PROPOSED OFFICE REMODEL
119 WASHINGTON AVE SU. 502
MIAMI BEACH, FL

April 12, 2019

Re: BC1910562

Below please find our responses to Disapproval Remarks regarding the above referenced project.

sheet
A-2

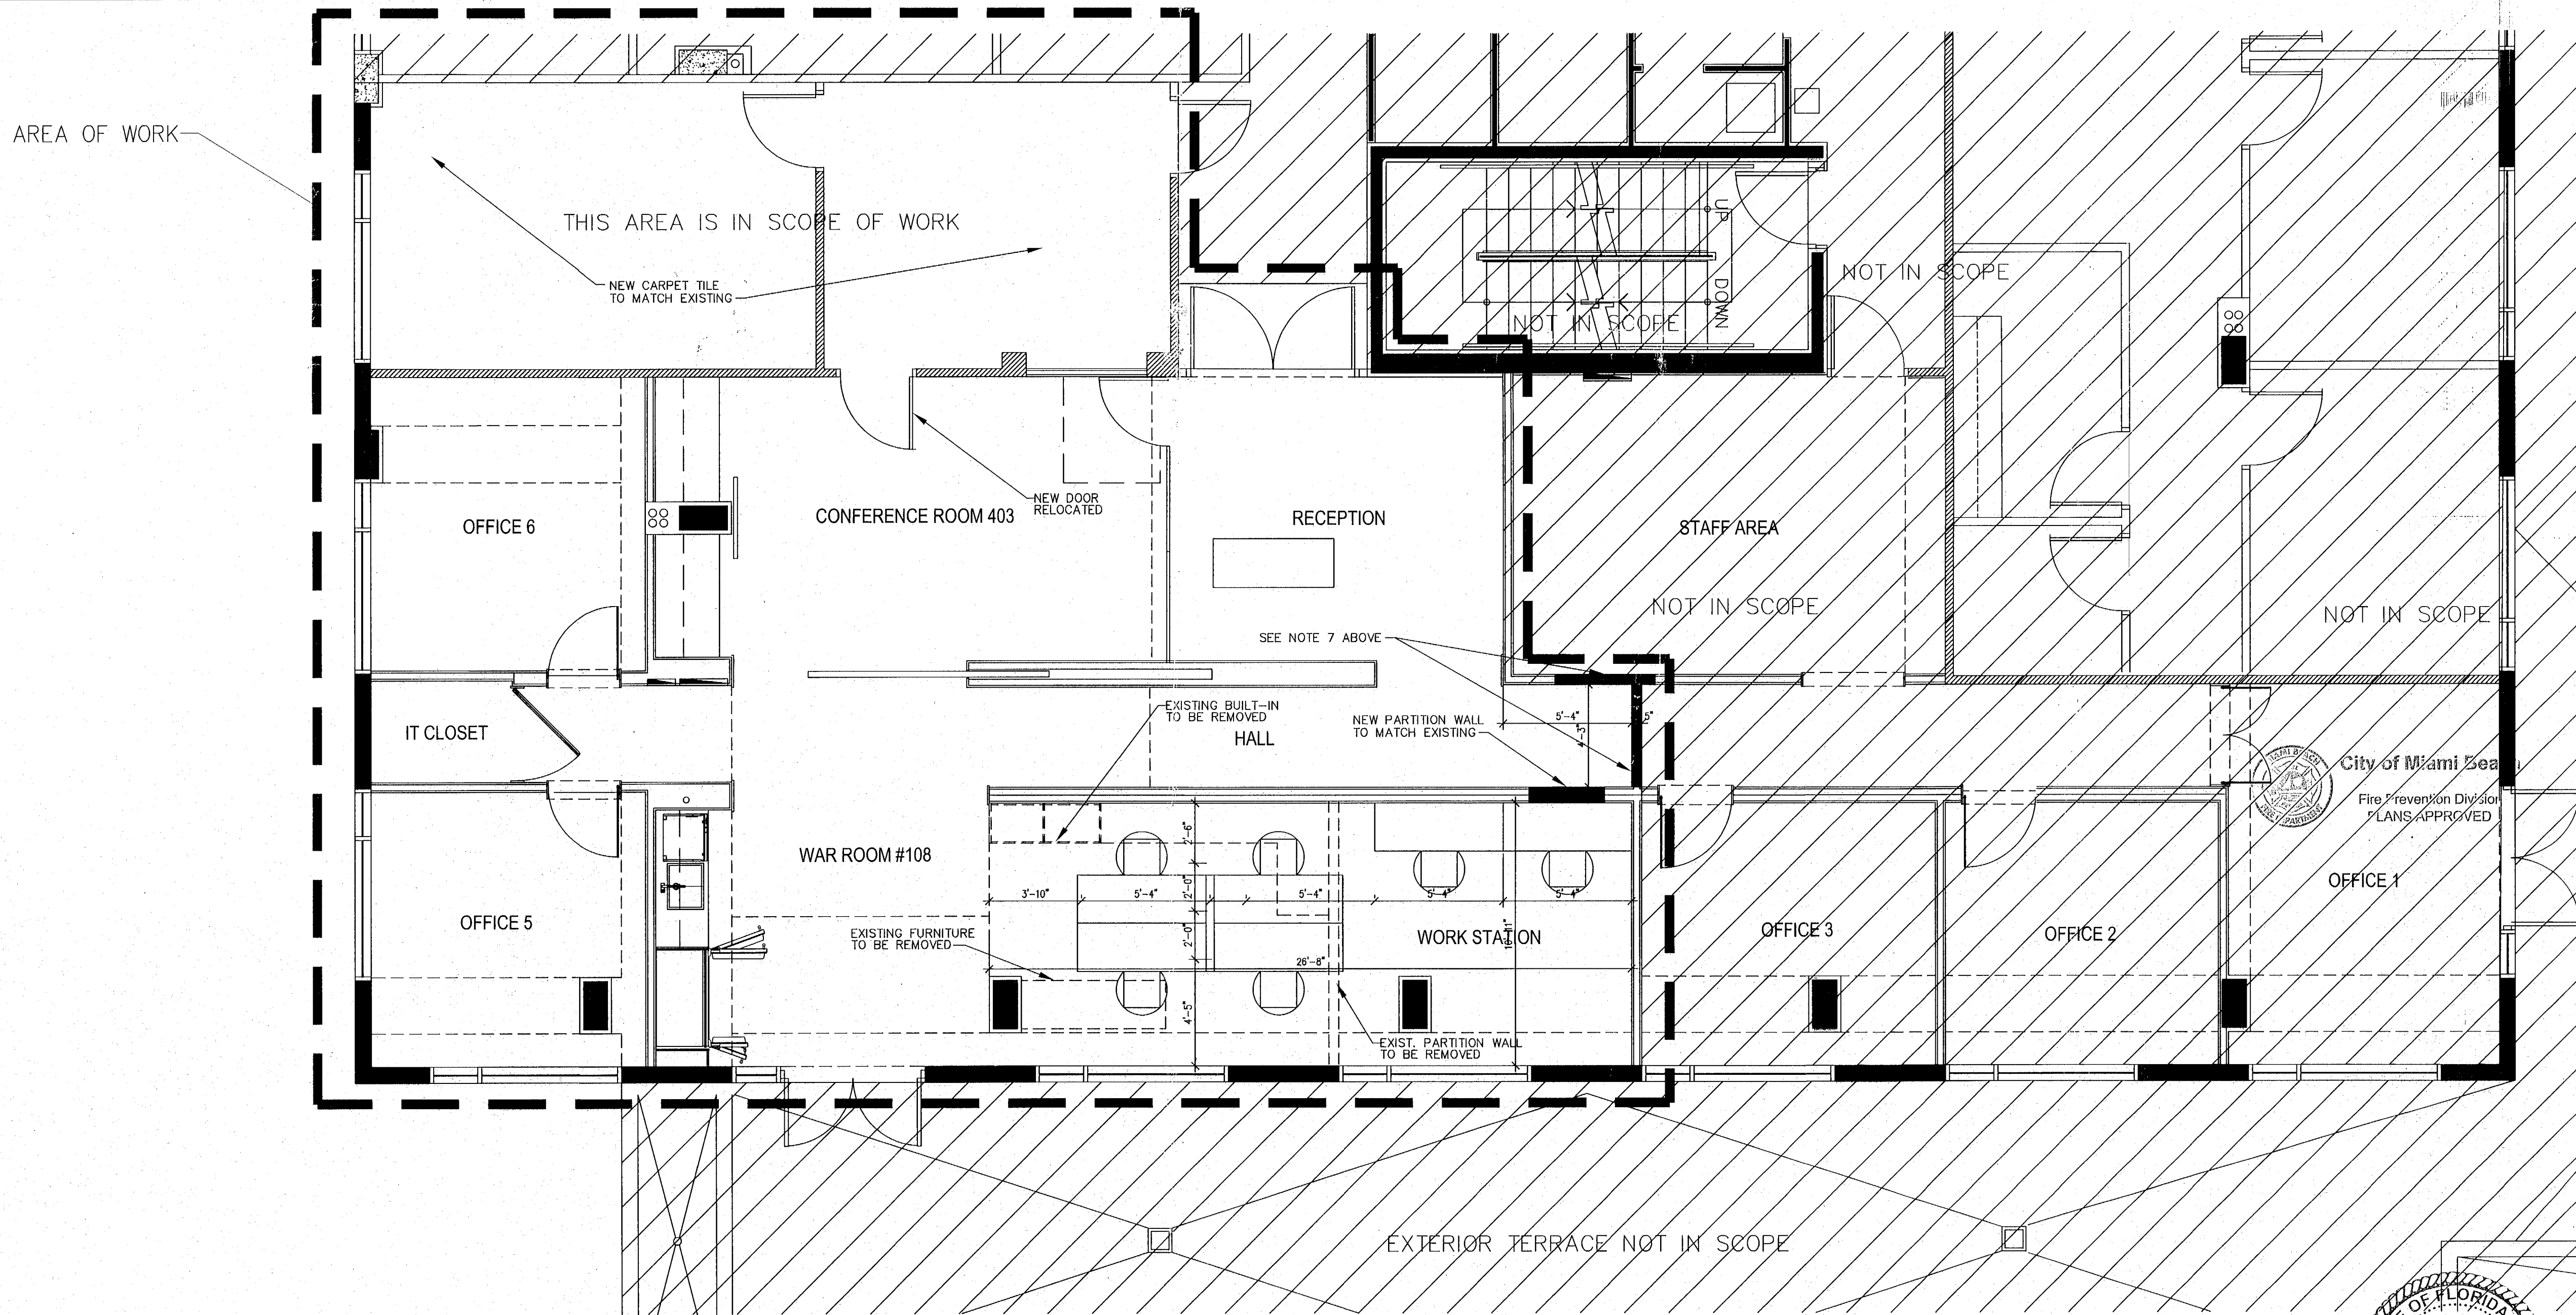
4. Codes to be applicable shall be clearly written on the first page of plans. State that code in effect is FLORIDA BUILDING CODE 2017, 6th Edition and FLORIDA BUILDING CODE ACCESSIBILITY 2017, 6th Edition. All other applicable codes for the other trades must be listed. If the proposed work is on an existing building work shall be classified as per FBCBE (Existing) 2017 Chapter 5.

5. Occupancy classification group and sub-group shall be determined (see Chapter 3). Group A with less than 50 people is considered a group B (business). If special occupancies apply see requirements in Chapter 4. FBCB 107.3.5

6. Calculate occupant load and compare it with egress capacity. FBCB 107.3.5, & table 1004.1.2.

7. Show details with an NRTL approved system (UL or equal) number for all fire rated walls, partitions, fire barriers, Chases, etc. FBCB Chapter 7

8. Provide sound insulation: Walls, partitions and floor-ceiling assemblies separating dwelling units from each other and from public or service areas shall have a sound transmission class (STC) of not less than 50 (66 for wood joists floor). Floor assemblies shall also have an impact insulation class (IIC) of not less than 50 (66 for wood joists floor). FBCB 1207

See revised sheet A-2

See revised sheet A-2

See revised sheet A-2

See revised sheet A-2

See new detail U419 sheet A-2
